Eskom	Tender Questions and Answers	Document Identifier	240-7124948	Rev	1
		Effective Date	01 April 2023		
		Review Date	April 2026

Request for Enquiry Number	E1256CXMWP
Description / Project Title	TO ENGINEER, PROCURE AND CONSTRUCT A WATER ELECTROLYSIS HYDROGEN GENERATION PLANT, WHICH MUST BE INTEGRATED WITH THE EXISTING RENEWABLE POWER PLANT FOR “GREEN H2 PRODUCTION” AT ERIC ROSHERVILLE FOR A PERIOD OF THREE (3) YEARS.
Tender Questions Closing Date	25 JULY 2025

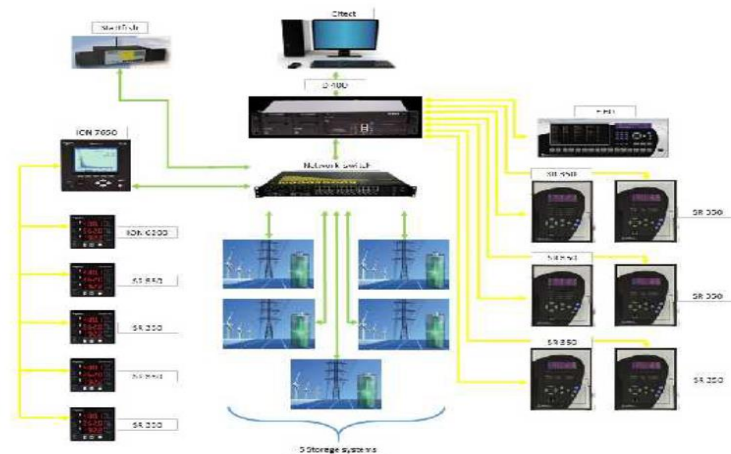
27.		The SCADA needs to interface with the PV plant and BESS, we would need to know what the existing control systems are to ensure that we allow for the correct network interface licencing and protocol support functionality. Please could this information be provided.	<p><b>Clarification for the PV Plant:</b></p> <p>The interface to the PV plant will be via the PV Plant Supply LV Panel located in the NW substation. In the panel there's an energy and power quality meter indicating the PV plant production. The meter is PowerLogic ION8650 that supports Modbus, DNP 3.0, IEC61850 protocols, Serial RS485 connections also supported.</p> <p>Also, part of the control system in the PV plant LV panel is the Siemens protection relay for voltage and frequency (7SR158), also supports Modbus, DNP 3.0, IEC60870-5-103 protocols, Serial RS485 connections also supported.</p> <p><b>Clarification for the BESS plant:</b></p>	18/06/2025

An overview of the communication used between the various instruments and storage systems can be found in block diagram 1. The two communication types used within the battery system are RS485 (depicted in yellow) and Modbus (depicted in green). RS 485 is used between the various protection relays as well as the power meters. The protection meters each have their own dedicated RS485 port on the D400 RTU (remote terminal unit), in the case of the ION 6200 meters, they are daisy chained to the ION 7650's RS485 port 2. From the ION 7650, data is transferred via Modbus to the LAN switch.
